The Woodlands Township

2026-2029 Waterway Square Tree and Lake Robbins Bridge Doves

C-2026-0294

Addendum 2

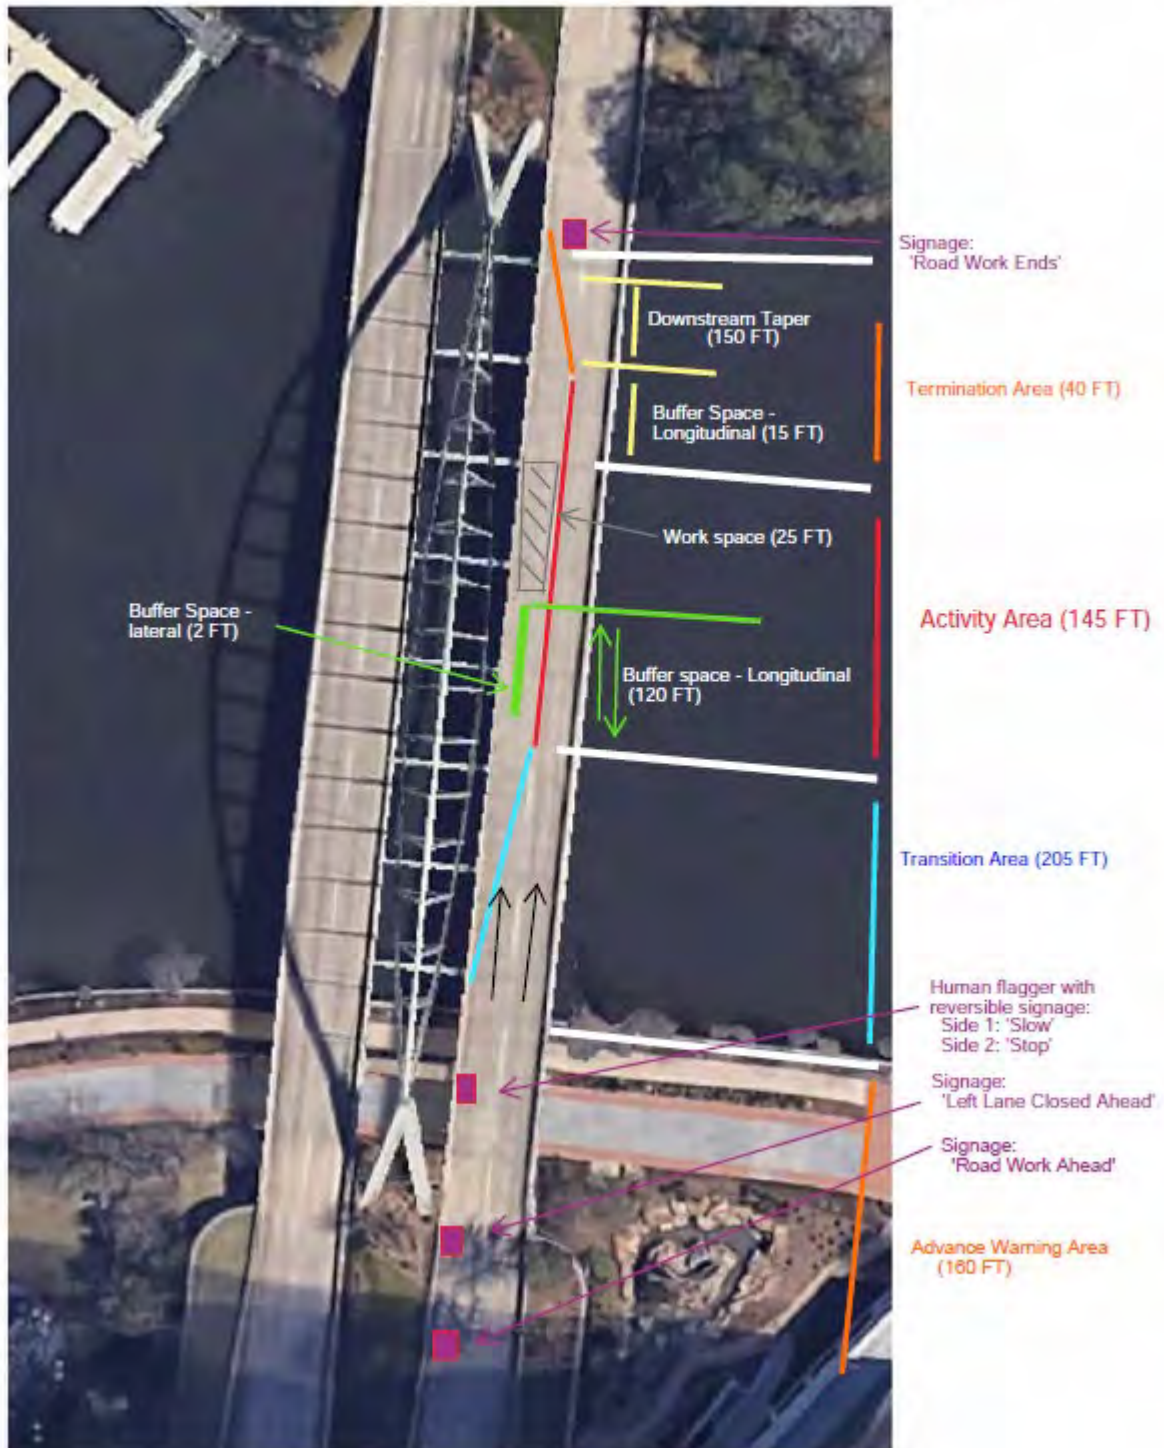
1. Question: Can the city provide a site map of the Waterway Square area, showing where contractor is to park to unload, and the approved path to be taken to get materials from the unload site, to the turf area where the tree is to be installed?

Answer: The Township can provide additional maps and will provide access to the Waterway Pathways which can accommodate UTVs/Service Vehicles. See Red Line on map for UTV access. Blue Line indicates 2 parallel parking spaces available. Yellow line indicates steps down to the lower level of the park.
